Product Change Notification

Change Notification #: PCN114941-00
Change Title: Intel® Server Product A1U2PXR3HDAIC
PCN114941-00, Product Design,
Cable replacement
Date of Publication: October 1, 2016

Pre-change Cable with “left” connectors

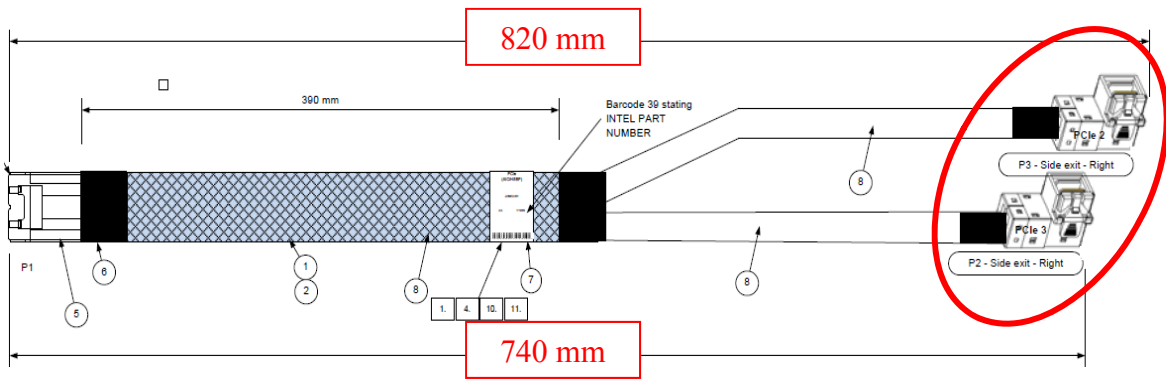
Intel is implementing the following changes on the cable included into the Intel® 1U Riser3 Re-Timer Kit A1U2PXR3HDAIC to allow more convenient cable routing.

- Orientation of the connectors attaching to the re-timer card will change from “left” to “right”
- The length of the cable will be extended by 20 mm
